LTR-NRC-17-77

Subject: Response to Revised November 21, 2016, U. S. Nuclear Regulatory Commission Request for Additional Information for Westinghouse Electric Company Topical Report WCAP-17794-P, Revision 0, and WCAP-17794-NP, Revision 0, "10x10 SVEA Fuel Critical Power Experiments and New CPR Correlation: D5 for SVEA-96 OPTIMA3" (Proprietary/Non-Proprietary)

**REVISED NOVEMBER 21, 2016, U. S. NUCLEAR REGULATORY  
COMMISSION REQUEST FOR ADDITIONAL INFORMATION FOR  
WESTINGHOUSE ELECTRIC COMPANY  
TOPICAL REPORT WCAP-17794-P, REVISION 0, AND  
WCAP-17794-NP, REVISION 0, "10X10 SVEA FUEL CRITICAL POWER  
EXPERIMENTS AND NEW CPR CORRELATIONS: D5 FOR SVEA-96  
OPTIMA3" (TAC NO. MF3368)**

Figure A3-1: GNF’s Conceptual Pareto of Ordering of Contributing Factors (extracted from ADAMS ML1721SA338)

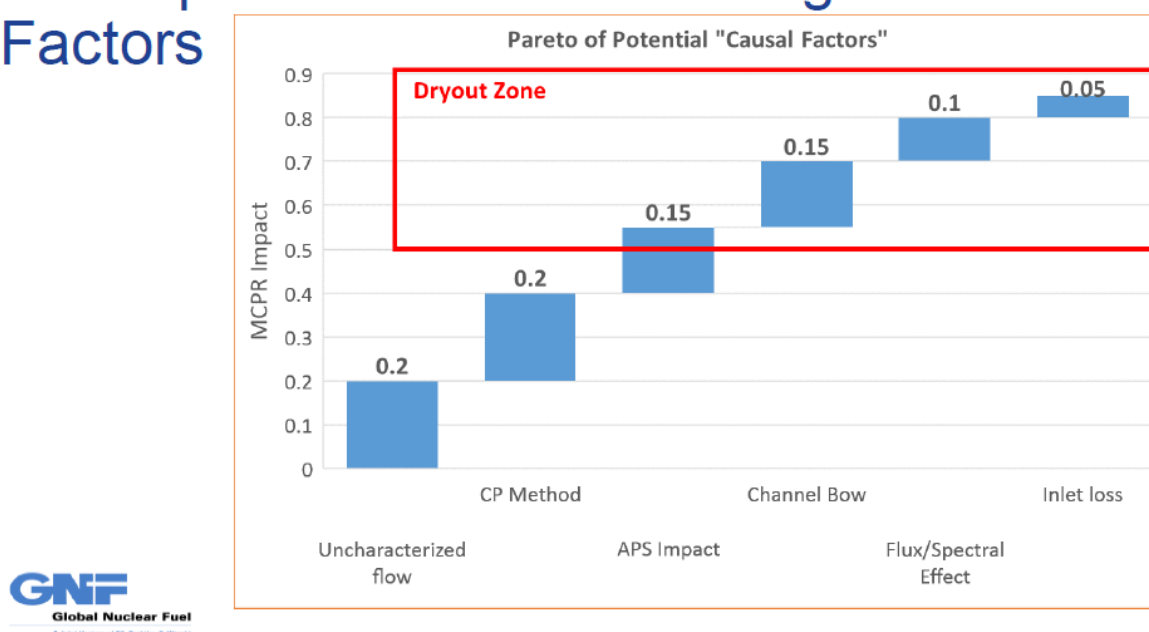
It has been argued by GNF, that the [ ]<sup>a,c</sup> dryout observations are best explained by an ordering influence of multiple contributing factors and inherent weaknesses of the SVEA design. The estimated MCPR impact according to information provided by GNF to the NRC, (ADAMS Accession Number ML1721SA338) is purported to be described in the figure below, extracted from the mentioned reference:

All of the contributions presented in Figure A3-1 have been previously evaluated by Westinghouse using all of the information available about the specific conditions at [ ]<sup>a,c</sup>. While Westinghouse agrees that these are all obvious factors to be considered based on past industry experiences, it has been demonstrated that they have no significant relevance to localized dryout observations, even when conservatively taken in combination. The relevance and potential magnitude of contribution of each factor are discussed below.
